END-OF-LINE INDICATOR ASSEMBLY

APPARATUS AFFECTED: 35A and 35B Teletypewriter Cabinets; 35A through 35E Electrical Service Units.

OBJECT: To improve visibility of the end-of-line indicator by placing it in the normal line of sight of the operator.

Fig. 1

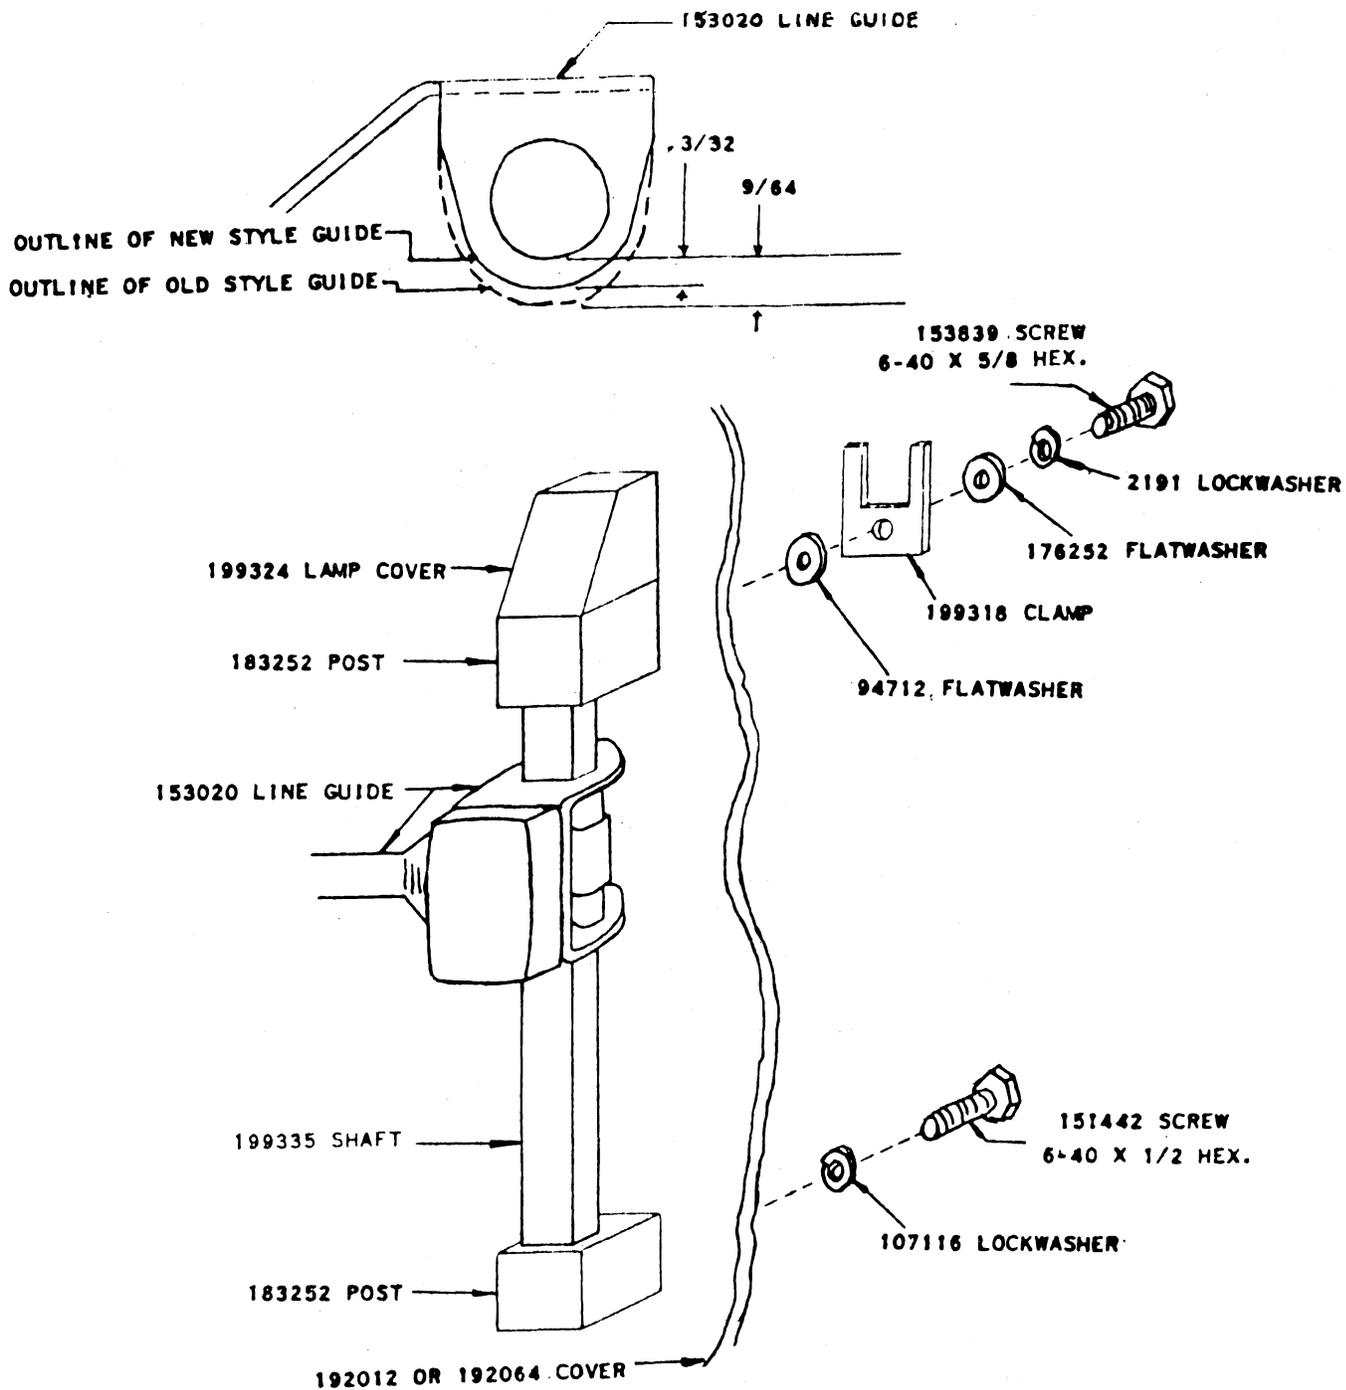
- (1) A 5/16-inch by 1/2-inch rectangular cutout has been added directly above the line guide shaft.
- (2) The TP199321 bracket and the TP199323 end-of-line indicator cable with associated hardware and cable clamps have been added. (Fig. 2)
- (3) On the TP192190 line guide assembly, the TP153020 line guide has been modified to allow greater clearance between the radial section of the guide and the cover. (Fig. 1) The following old style parts are replaced by new style parts:

<i>Old Style</i>	<i>New Style</i>
TP151722 screw (6-40 by 3/16)	TP153839 screw (6-40 by 5/8)
TP107116 lockwasher	TP2191 lockwasher
TP192193 shaft	TP199335 shaft
TP192192 bushing	TP183252 post (2)
	TP94712 flat washer
	TP176252 flat washer
	TP199318 clamp
	TP199324 lamp cover, red

Fig. 2

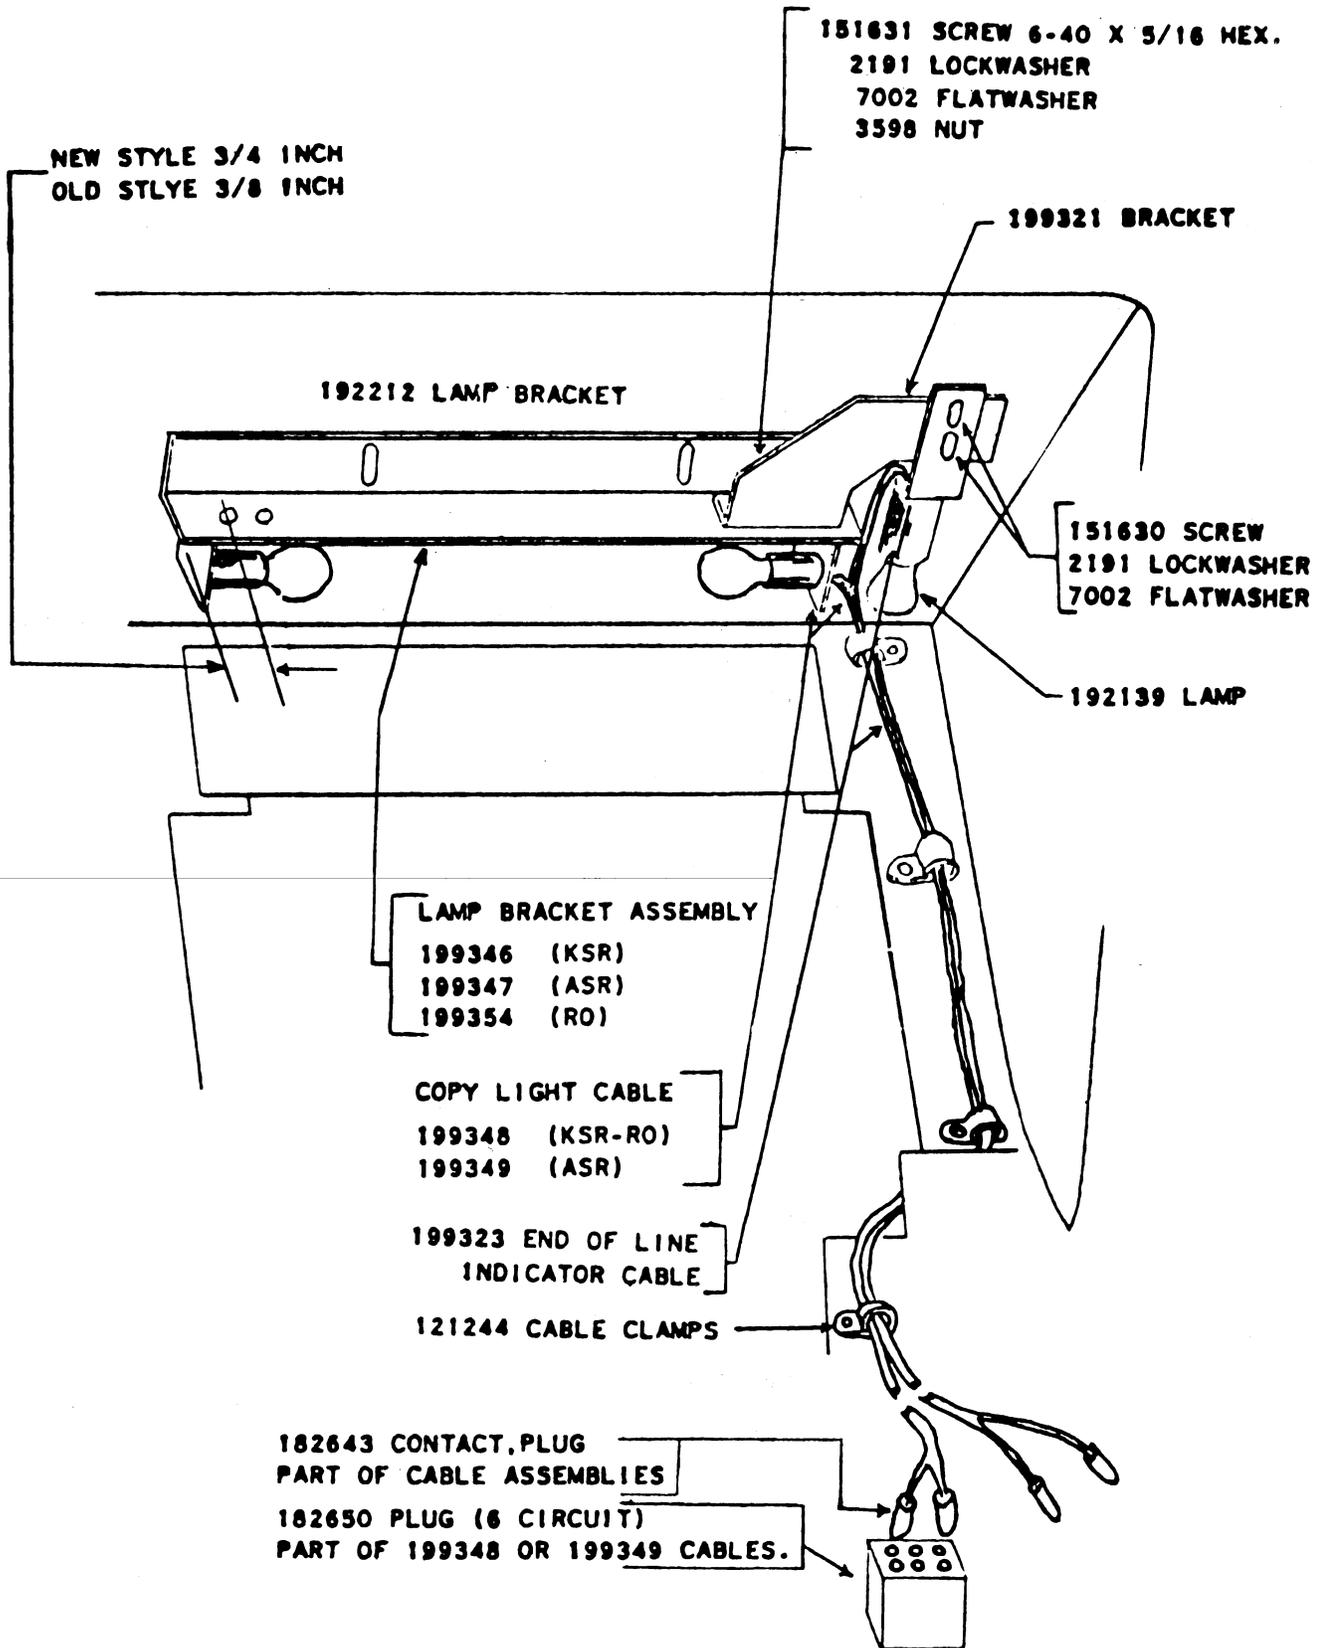
- (4) The TP192205 and TP192248 lamp bracket assemblies are replaced as follows (Fig. 2):

<i>Old Style</i>	<i>New Style</i>
TP192205	TP199346 lamp bracket assembly (KSR)
TP192205	TP199354 lamp bracket assembly (RO)
TP192248	TP199347 lamp bracket assembly (ASR)

- (5) The TP192215 and TP192252 copylight cable assemblies are replaced by the TP199348 (KSR, RO) and the TP199349 (ASR) copylight cable assemblies respectively. (Fig. 2)

Fig. 3

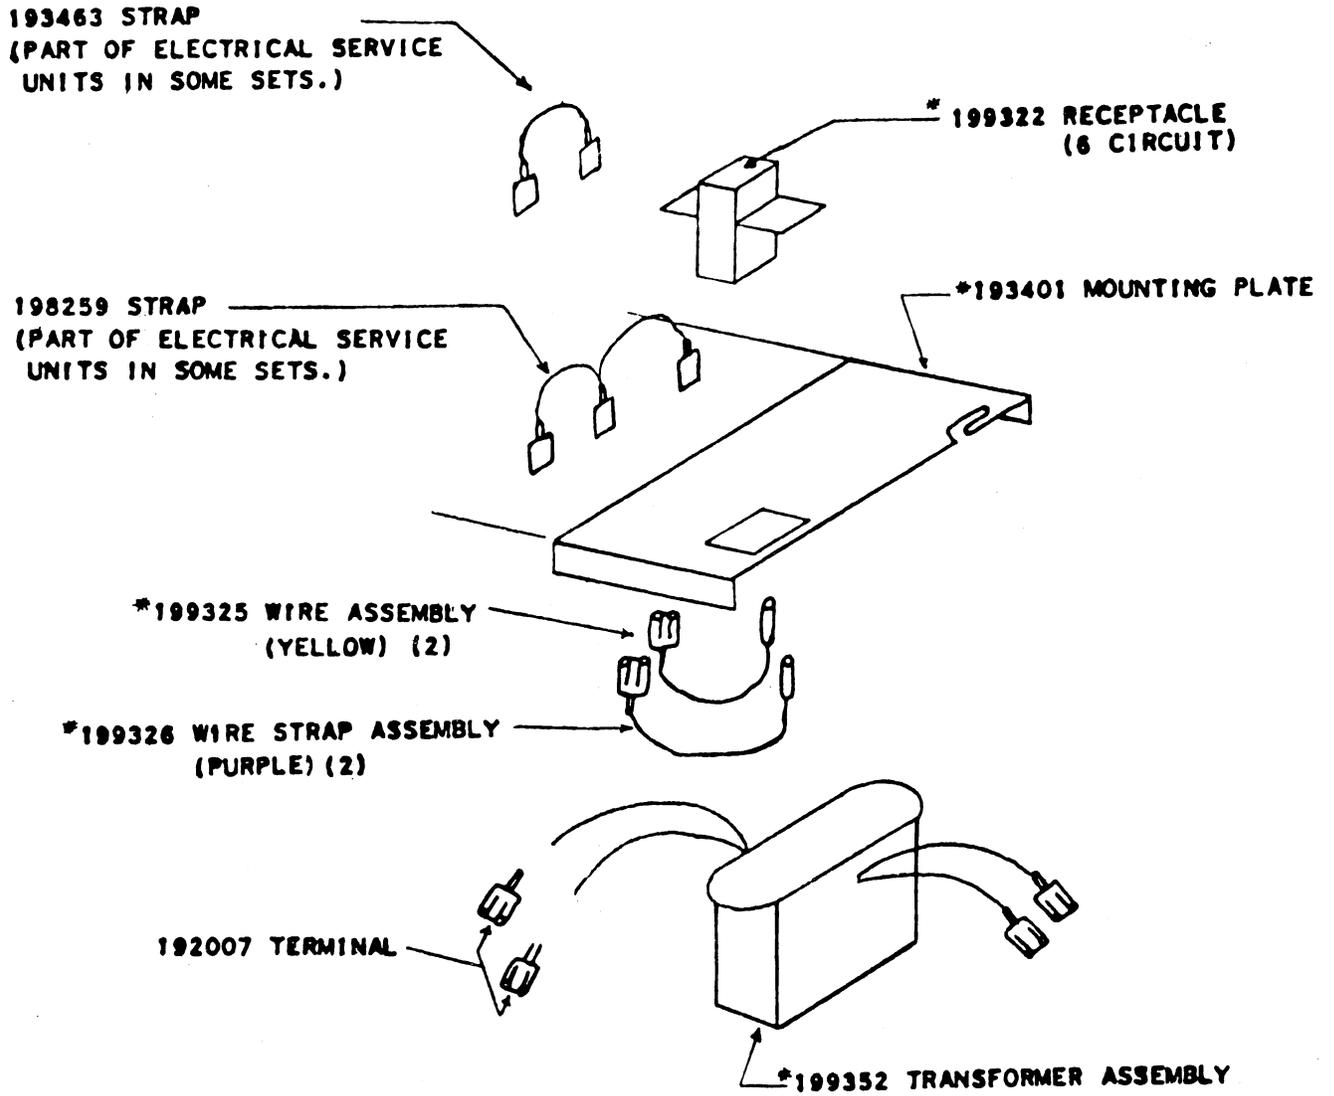
35A through 35E Electrical Service Units: The TP193411 copylight transformer assembly has been replaced by the TP199350 copylight transformer assembly. (Fig. 3)
